## HINCKLEY RAIL FREIGHT TERMINAL

Response to Secretary of State's Interim Decision and Tritax Responses

CPRE Leicestershire: Unique Reference: 20038675

February 2025

Figure 7.1 illustrates what various carriageway widths can accommodate. They are not necessarily recommendations.

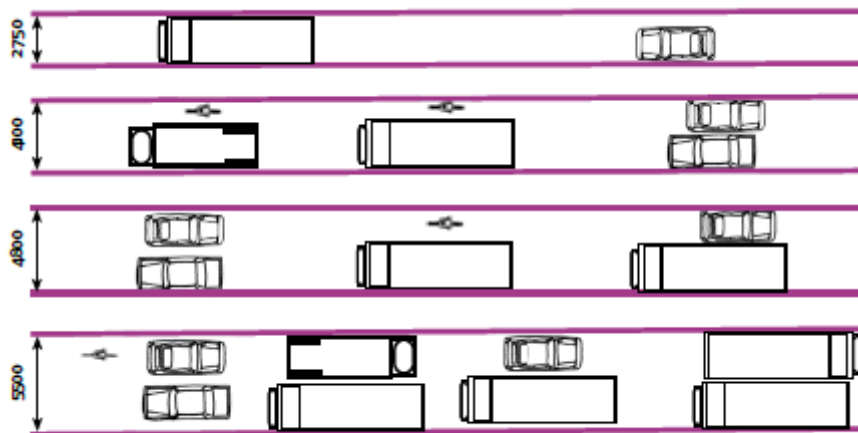
2.4.8 It is suggested by Tritax (based on Figure 7.1 of Manual for Streets, MfS) that this remains a suitable width for other vehicles to pass.

2.4.9 However, Tritax do not include the significant caveats to that diagram in MfS. Para 7.2.2 of MfS says:

2.4.11 In terms of width, we know an HGV can be 2.55 m wide and some SUVs over 2m wide. A Ford Transit van is 2.4 m wide. There is also the issue of wing mirrors. Fig 6.18 of Manual for Streets (also not quoted by Tritax) adds a further 0.25 for wing mirrors on either side, which creates a minimum width of at least 4.8m for two LGVs to pass if they touch mirrors together.

2.4.12 The 4.8 m width would simply not allow any vehicle to safely pass an HGV on that section of road, even at slow speed, without using the pavement.

Figure 6.18 Private and commercial motor-vehicles – typical dimensions.

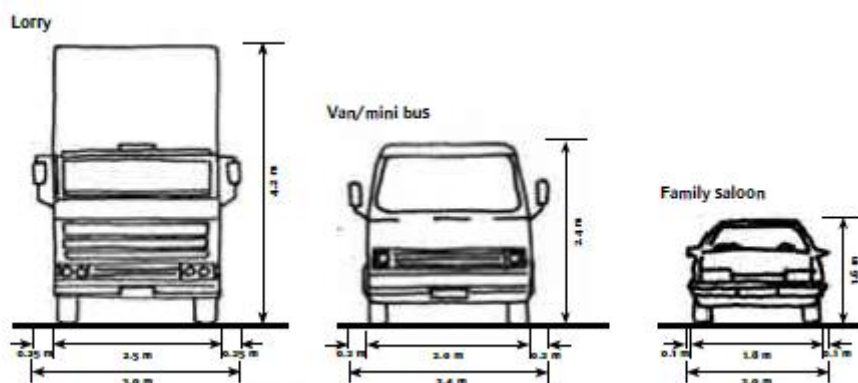
2.4.13 MfS also says these tolerances are appropriate for a speed limit of 20 mph. That is less than the 30 mph speed limit on the B4669. MfS also specifically excludes ‘short stretches of single lane working in two-way streets’, which is precisely what is envisaged by assuming HGVs will use the centre of the carriageway, to the exclusion of other vehicles.

Figure 8: Strava Cycling Heatmap

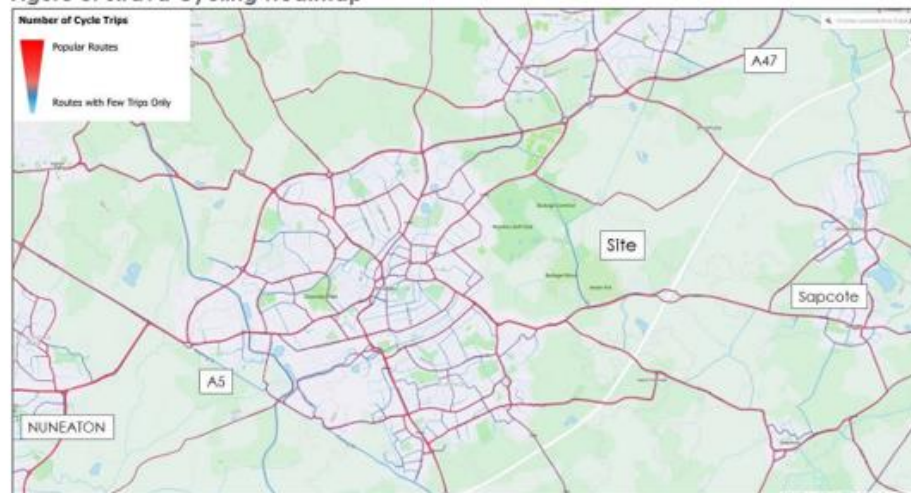
2.4.55 There is little consideration of cyclists, which we are told by Tritax average 20 per day, in the Technical Note. This again may mask higher numbers at the weekend and organised groups. The Strava Heatmap provided in the Sustainable  
2.4.56 Transport Strategy (and quoted by Tritax elsewhere) has the route marked down as popular.
